AMENDMENT OF SOLICITATION/MODIFICATION OF CONTRACT			1. CONTRACT ID CODE	PAGE OF PAGES	
			J	1	46
2. AMENDMENT/MODIFICATION NO. 0003	3. EFFECTIVE DATE 29-Jun-2004	4. REQUISITION/PURCHASE REQ. NO. W16ROE-4068-6489		5. PROJECT NO.(If applicable)

14. DESCRIPTION OF AMENDMENT/MODIFICATION (Organized by UCF section headings, including solicitation/contract subject matter where feasible.) The purpose of this amendment is to: 1) Incorporate attendance sheets of the attendees and pre-proposal slides for the pre-proposal conference held on 17 June 2004. 2) Incorporate pre-proposal conference questions and answers. Answers are for informational purposes only. 3) Incorporate a revised bid schedule. 4) Incorporate changes to the specifications sections and Standard Form 1442. The proposal due date remains unchanged, 19 July 2004 at 2:00pm local time. All other terms and conditions remain unchanged as a result of this amendment.					
Except as provided herein, all terms and conditions of the document referenced in Item 9A or 10A, as heretofore changed, remains unchanged and in full force and effect.					
15A. NAME AND TITLE OF SIGNER (Type or print)			16A. NAME AND TITLE OF CONTRACTING OFFICER

Insert, Appendix L Existing Water Tower As-Built, Nov 17, 1941 and Planned Water Tower Drawing. (See attached drawing)

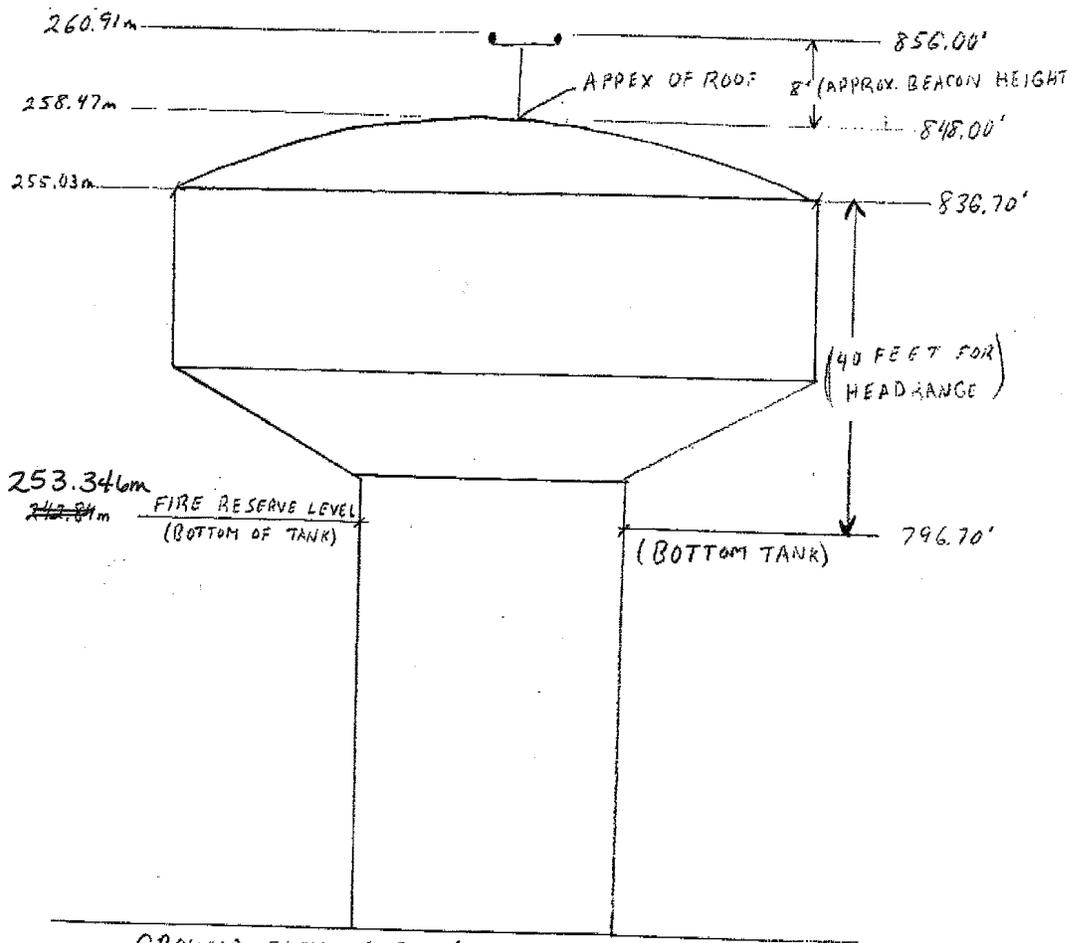
12. Is any additional information available on the existing water tower to be removed, such as drawings, cut sheets, etc.? Please provide the location of the existing tower.

36. Option D references the removal of an existing water tank and supporting structure. Does the supporting structure include the foundation? If so, please provide detailed information on the foundation including size, reinforcement, etc.

Section 01010, Option D – Decommission Existing Airfield Water Tower, Add after last section: “Reference, Appendix L – Existing Water Tower As-Built, Nov 17, 1941 and Planned Water Tower Drawing.”

ANS. Will provide a drawing of the existing tower and location under this amendment.

New Treatment Plant and Water Tower

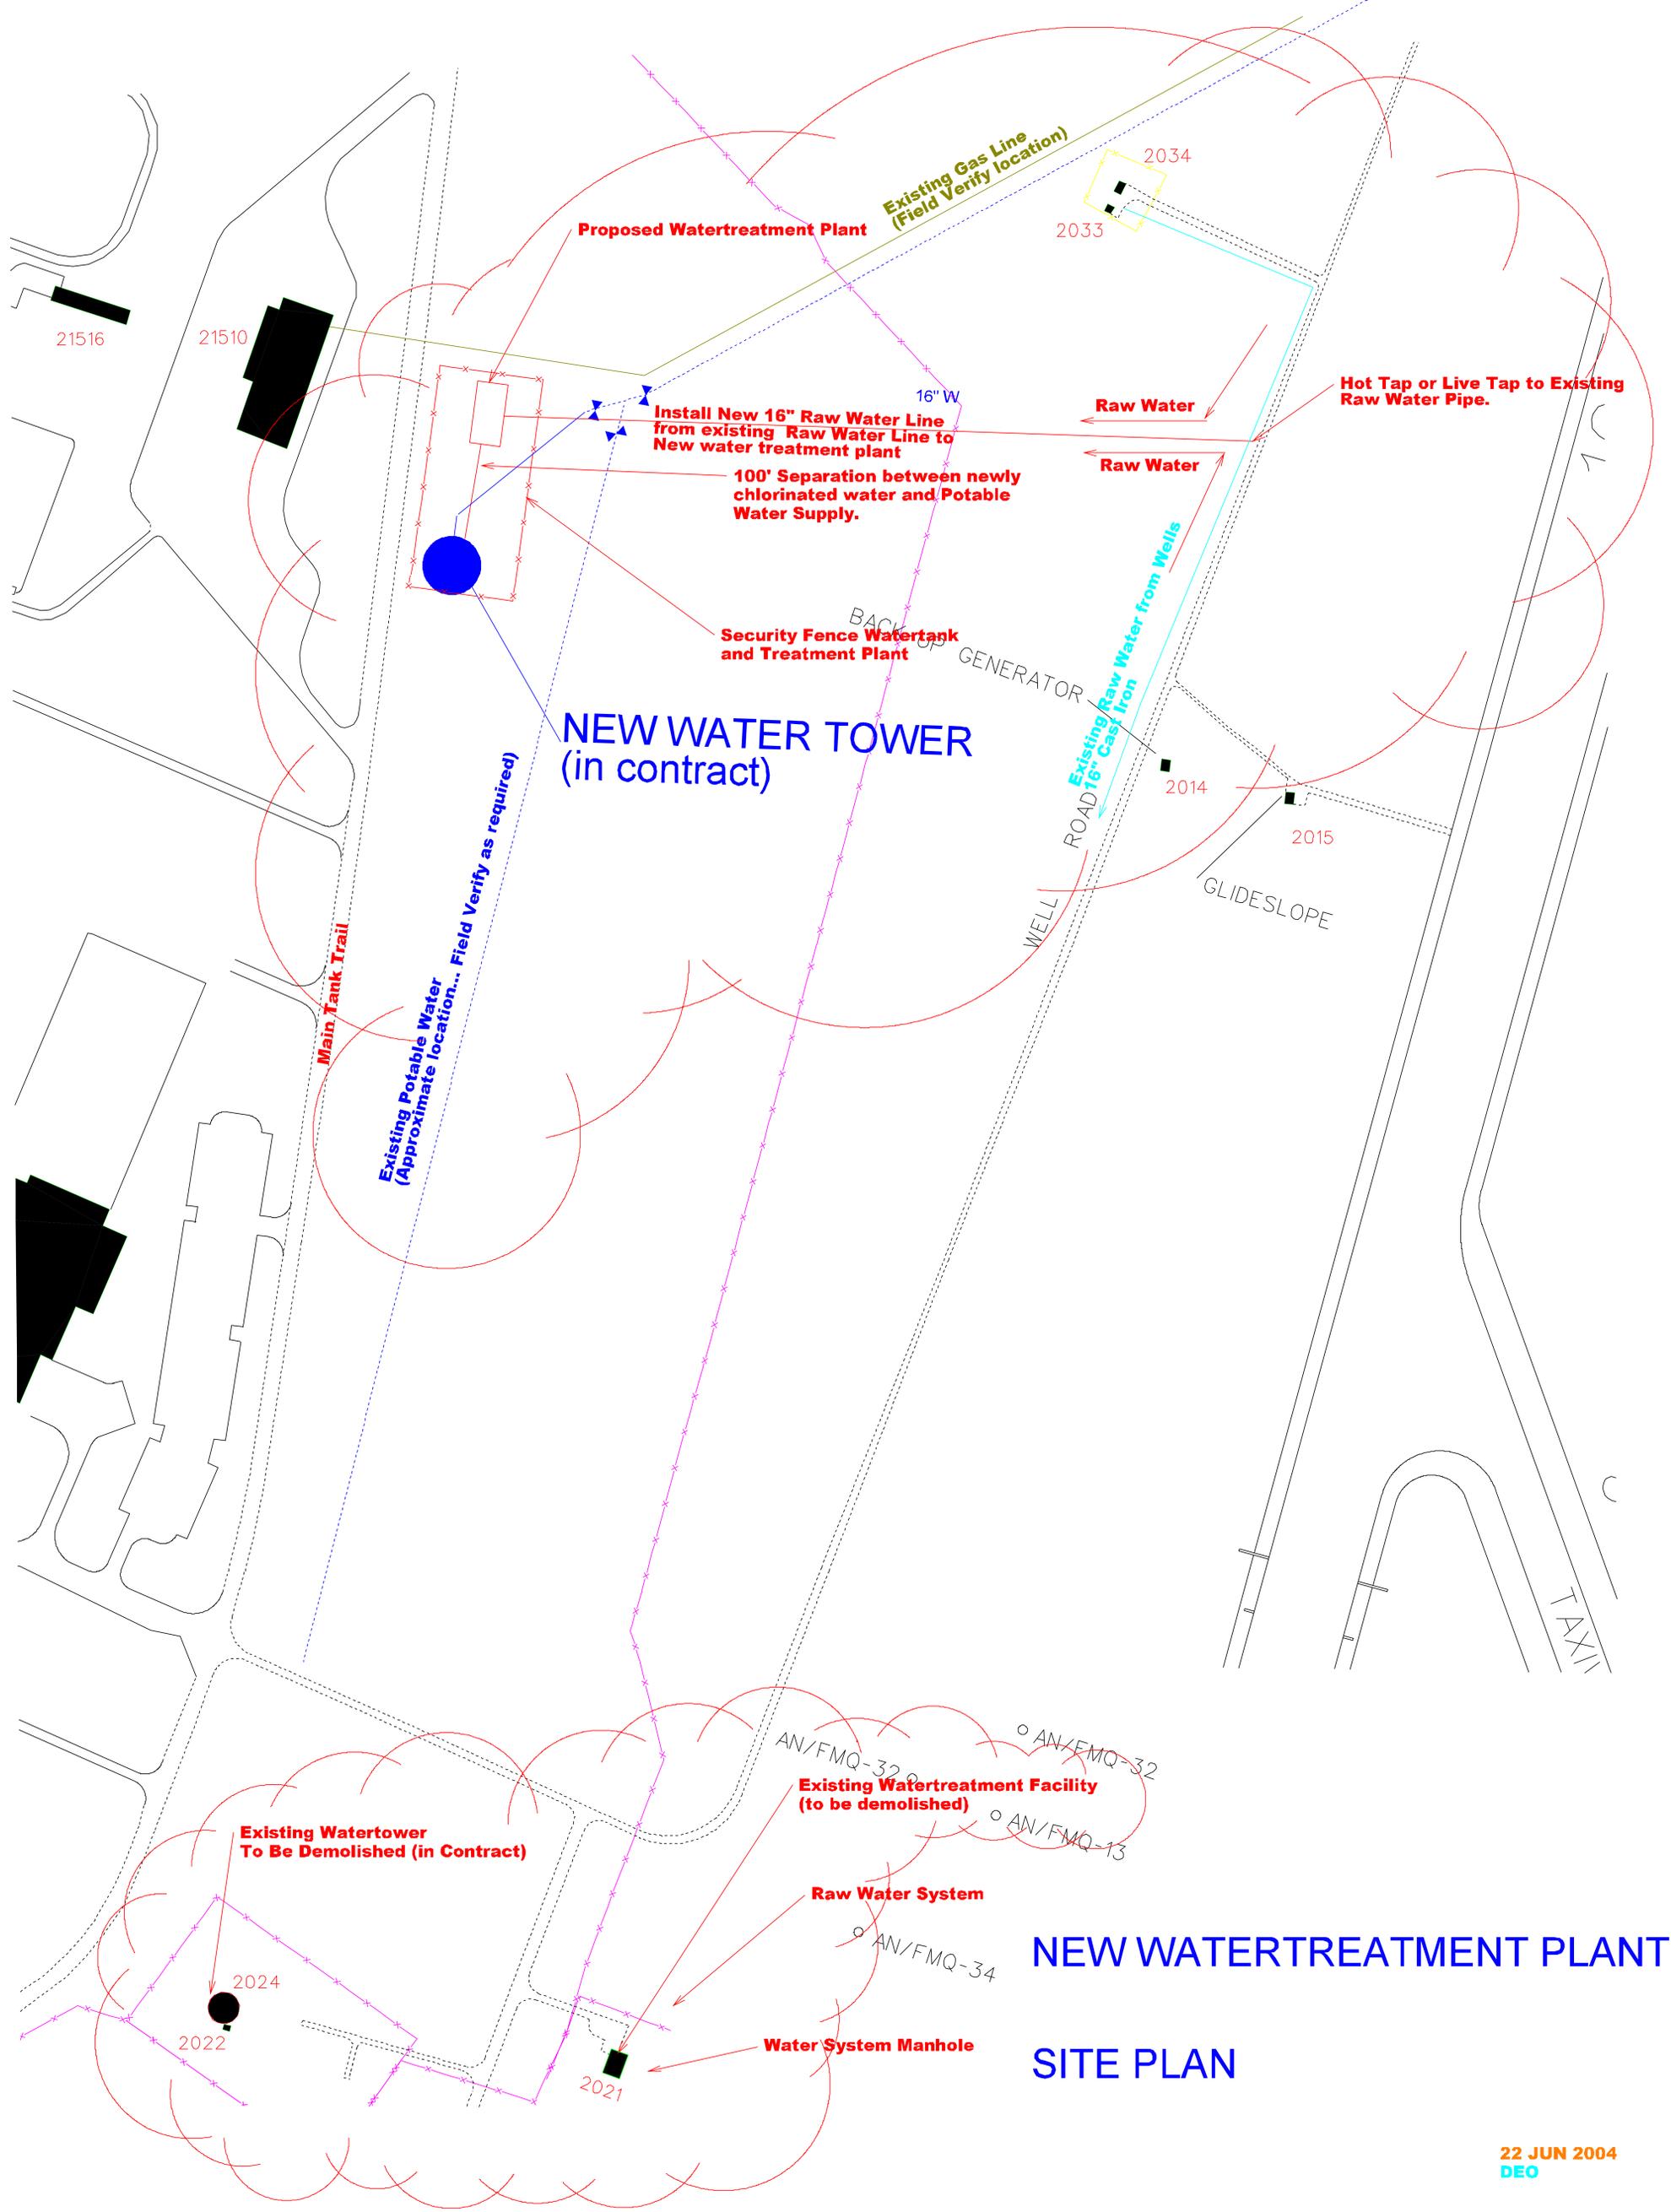
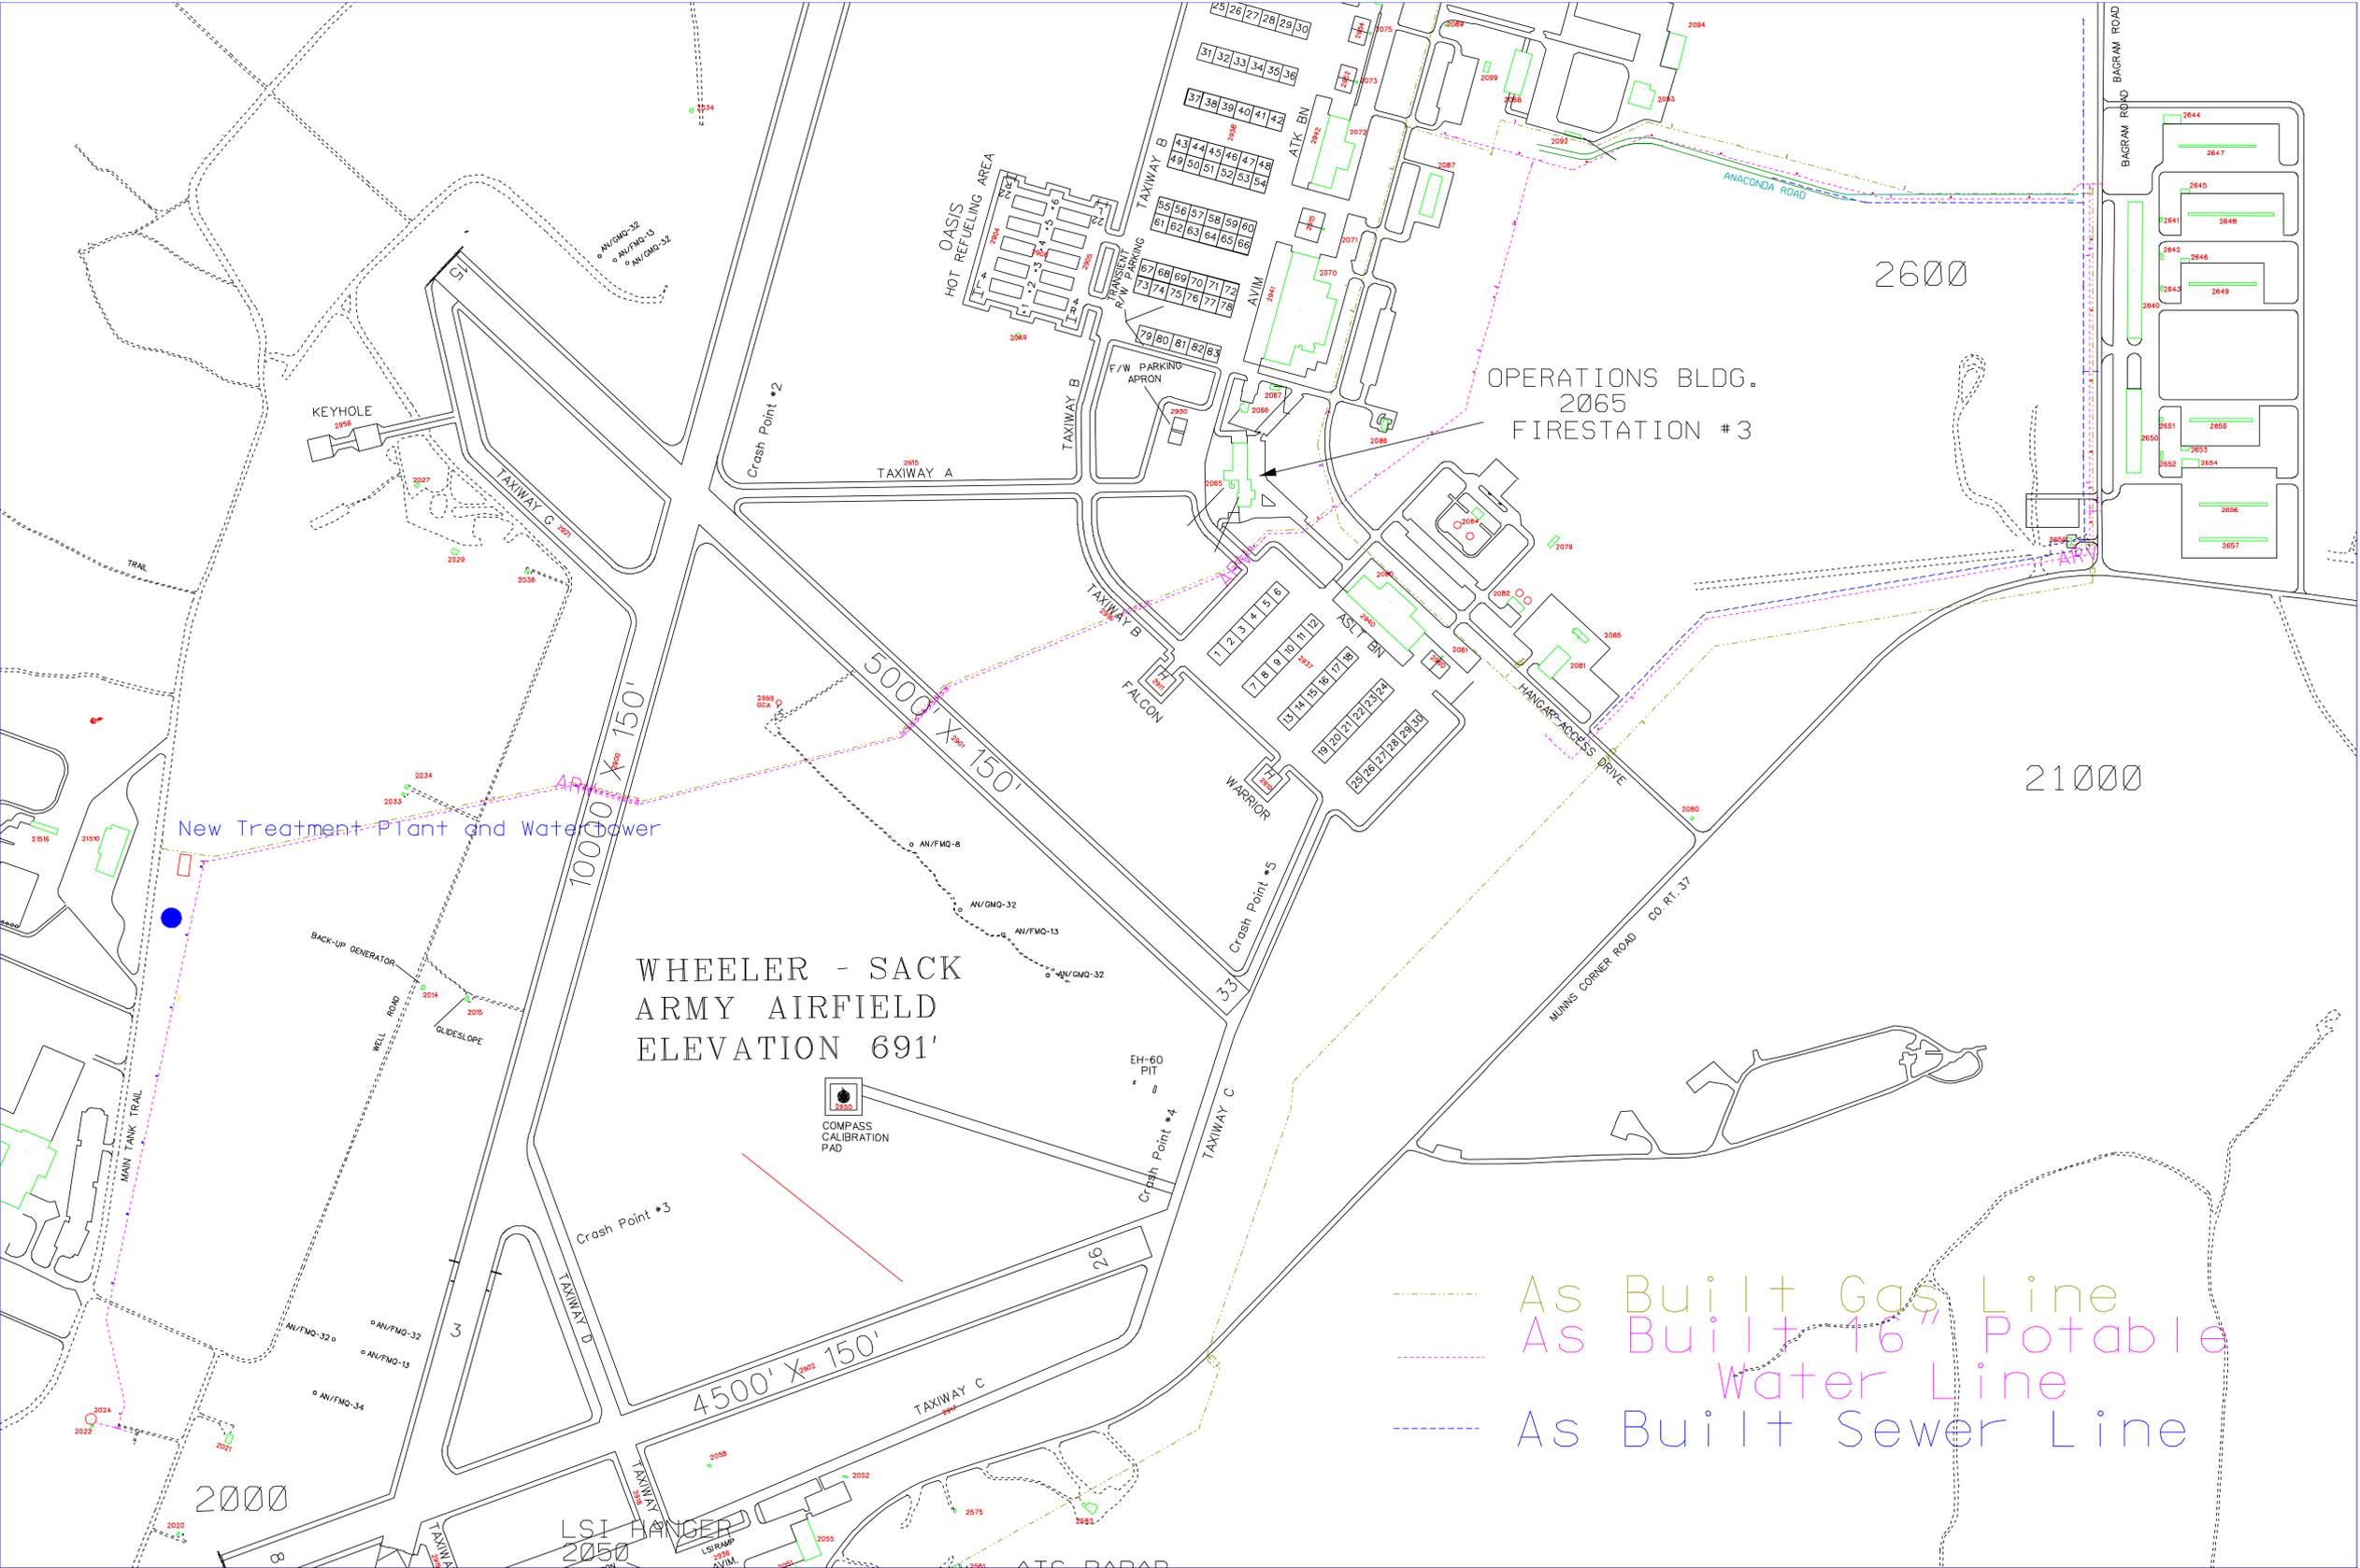
C. Insert New Drawing, Appendix-L, New Water Treatment Plant Site Plan.
